CITY OF Clemson SOUTH CAROLINA

Agenda, Clemson City Council July 15th, 2024 Council Chamber, Clemson City Hall

- a. Consider approving the construction contract with Harper Corporation for the construction of the Pendleton/Clemson Wastewater Treatment Plant expansion contingent upon the anticipated approval SC Rural Infrastructure Authority – Utilities Director Benjie McGill

E-925

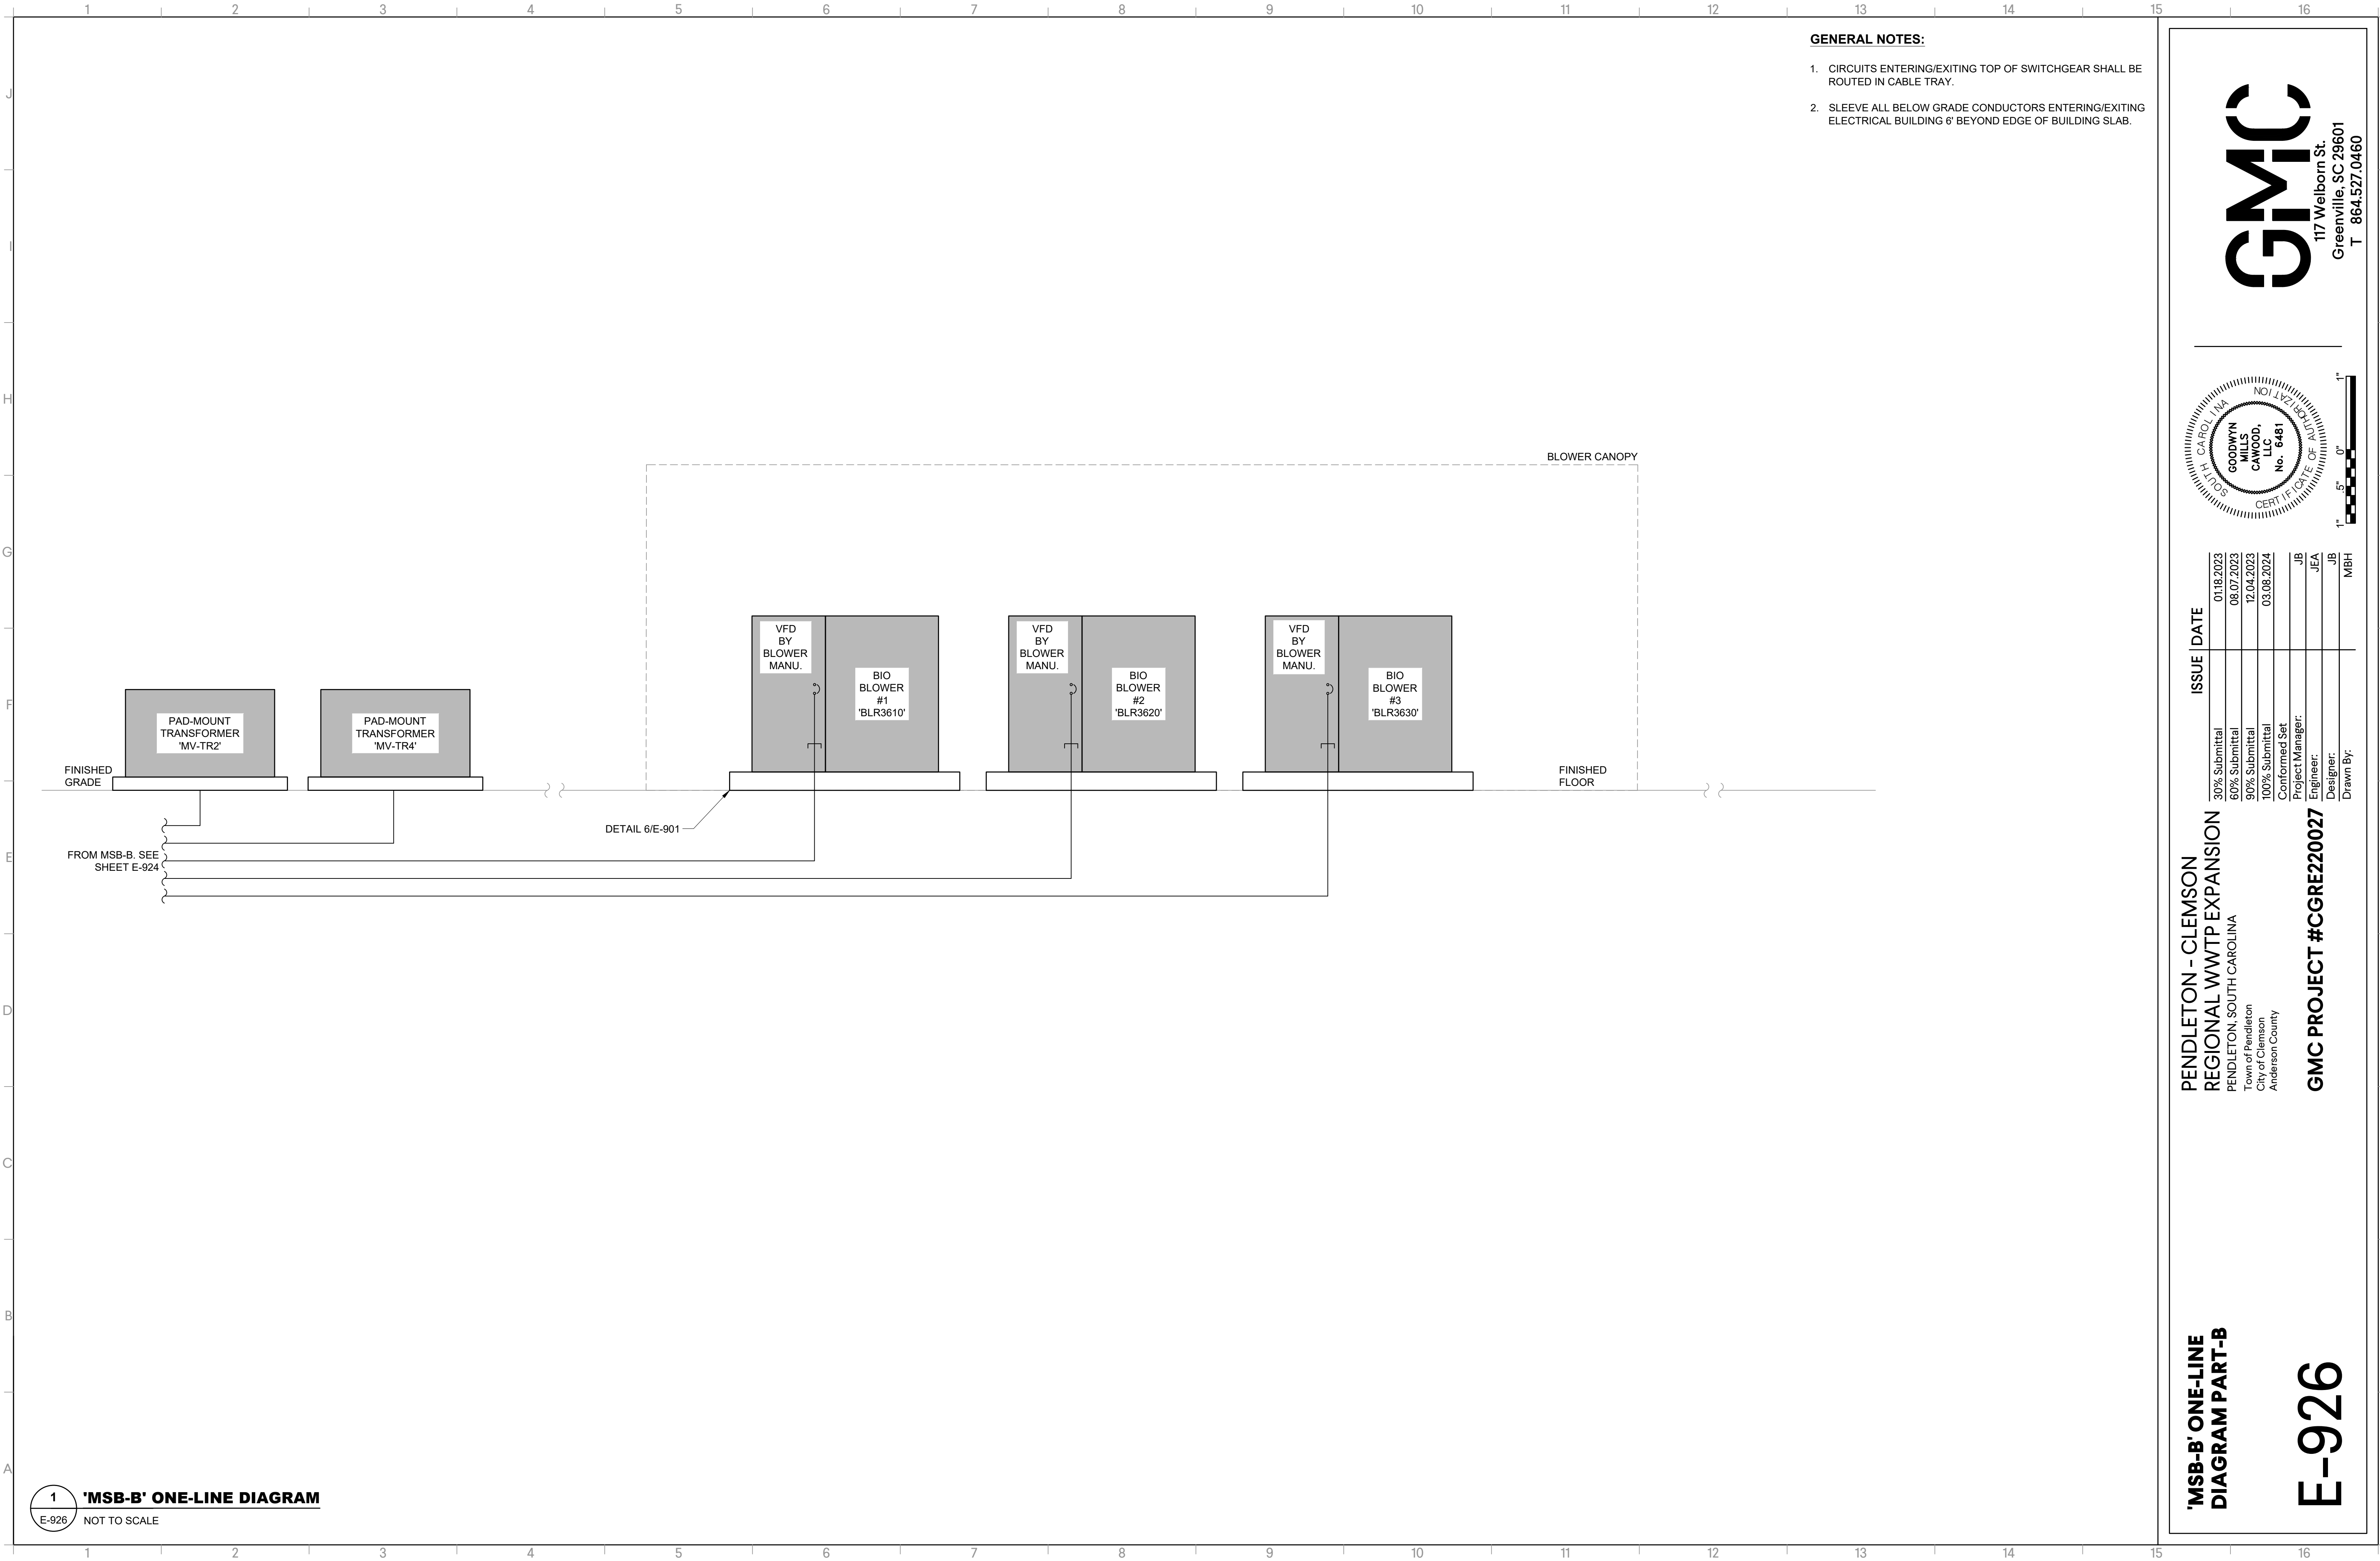
50	Electrical	Drawing E-923 contains a dry type transformer TR-LHW, but a kVA rating is not provided. Please confirm the rating required.	E-923		30 KVA	4.2.24	4.11.24		
51	Electrical	Drawing E-925 contains a dry type transformer TR-LEB2A, but a kVA rating is not provided. Please confirm the rating required.	E-925		45KVA. 45KVA applies to TR-LEB1A as well.	4.2.24	4.11.24		
52	Electrical	Drawing E-927 contains a dry type transformer TR-LBNR, but a kVA rating is not provided. Please confirm the rating required.	E-927		30KVA	4.2.24	4.11.24		
53	Electrical	Drawing E-927 contains a panelboard LBNR, but a panel schedule was not provided. Please provide a schedule if required.	E-927		See Additional Tabs in this Excel Workbook...	4.2.24	4.11.24		
54	Electrical	A specification was provided for dry type medium voltage transformers, however I do not see any indicated on the drawings as being required, unless those are the units on E-922 and E-926 that do not include ratings. Please confirm what's required.	E-922, E-926		MV-TR1 and MV-TR3 are step-up transformers rated 2000KVA; 480V Input; 4160V Output with 2-2.5% FCAN and 4-2.5% FCBN taps. MV-TR2 and MV-TR4 are step-down transformers rated 2000KVA; 480V Input; 4160V Output with 2-2.5% FCAN and 4-2.5% FCBN taps. Transformer degree rise shall be 115DEGC. Transformers can be Liquid-Filled or Dry-Type. Transformer enclosures shall be NEMA 3R.	4.2.24	4.11.24
